Monterey Bay Aquarium Research Institute 7700 Sandhold Road, Moss Landing, CA 95039	
Engineer Alana Sherman		Title BIAUV Xport Power Board	
Layout Jose Rosal	Size C	Document Number 10020653	Rev A
Date: Thursday, February 10, 2011	Sheet 1	of 2

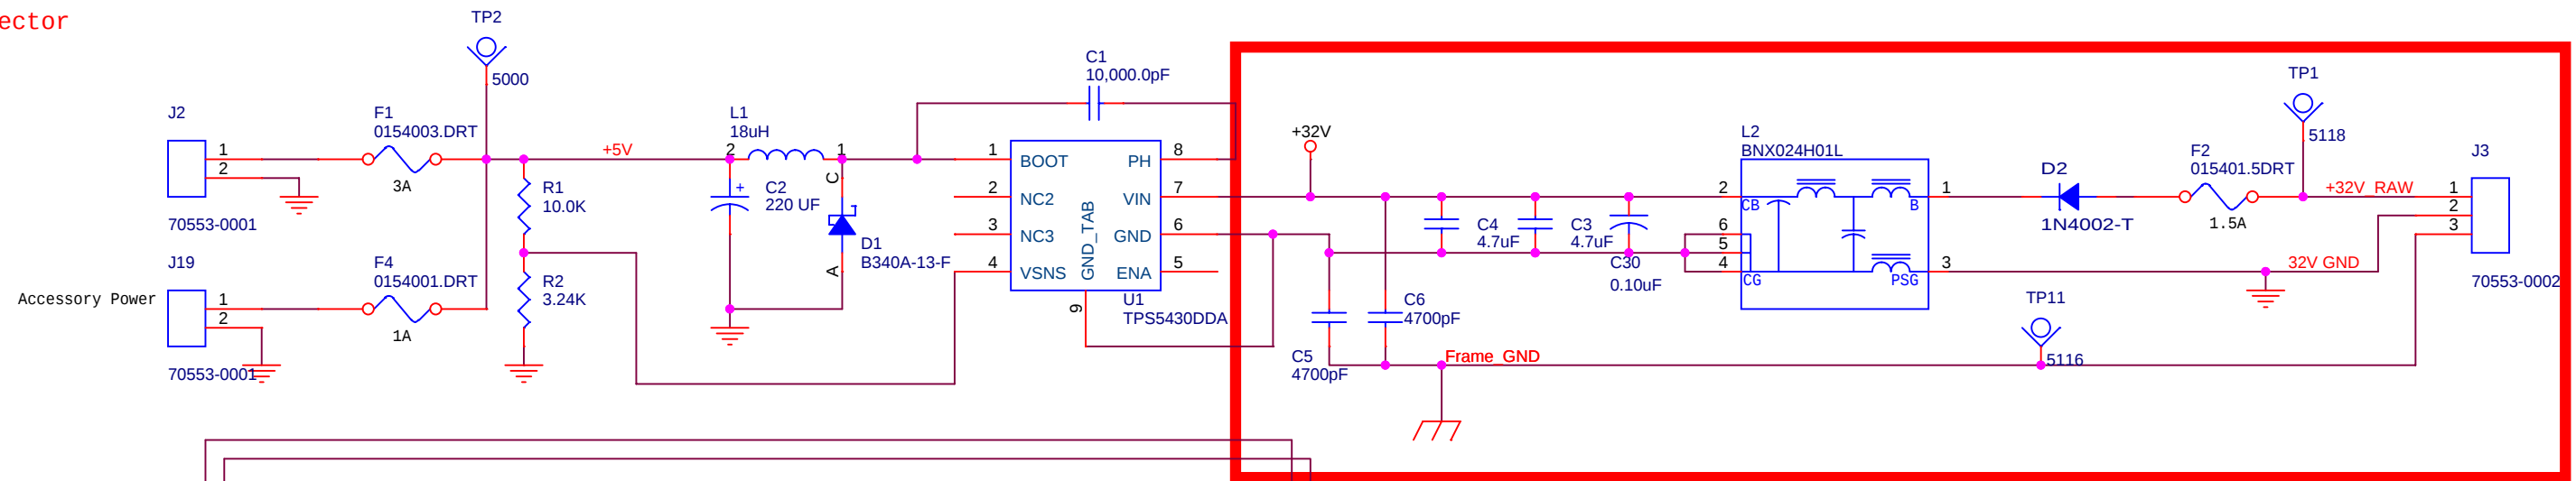
Changed connector size to 6 pins

Removed 12V power supply and changed connector to attach to Vicor controller board.

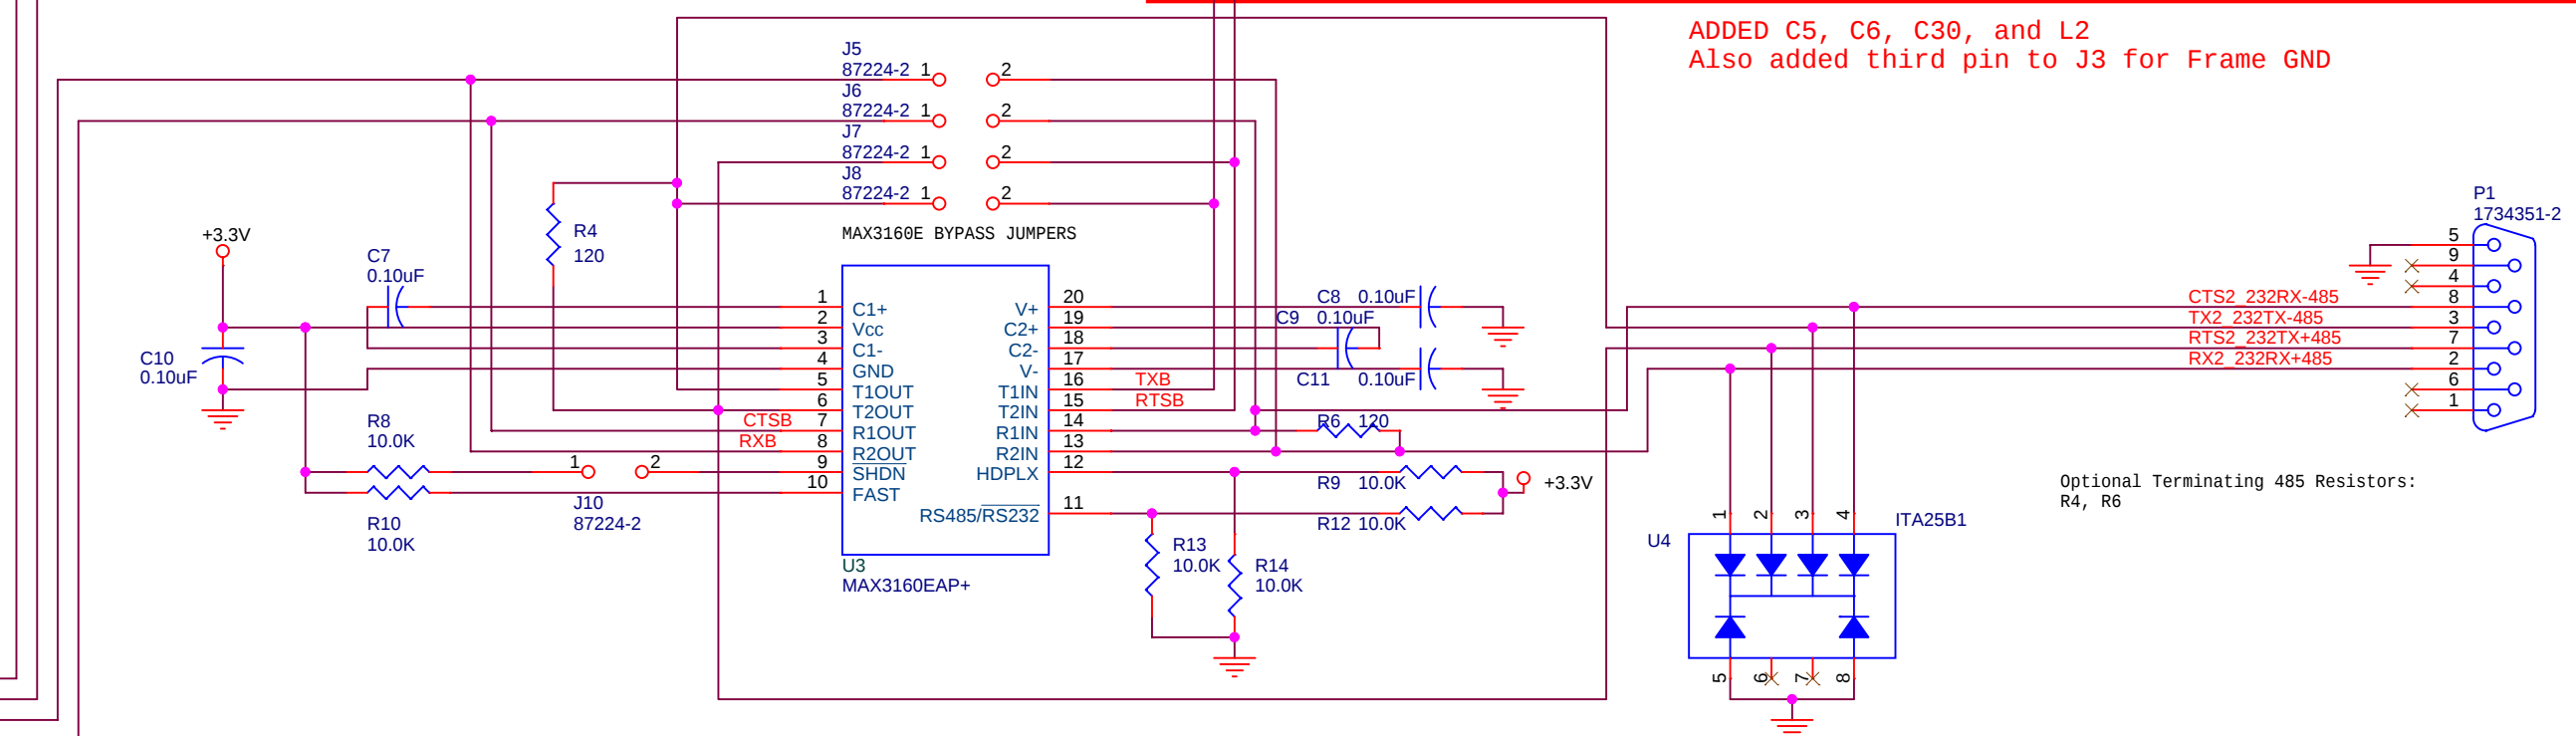
ADDED C5, C6, C30, and L2
Also added third pin to J3 for Frame GND
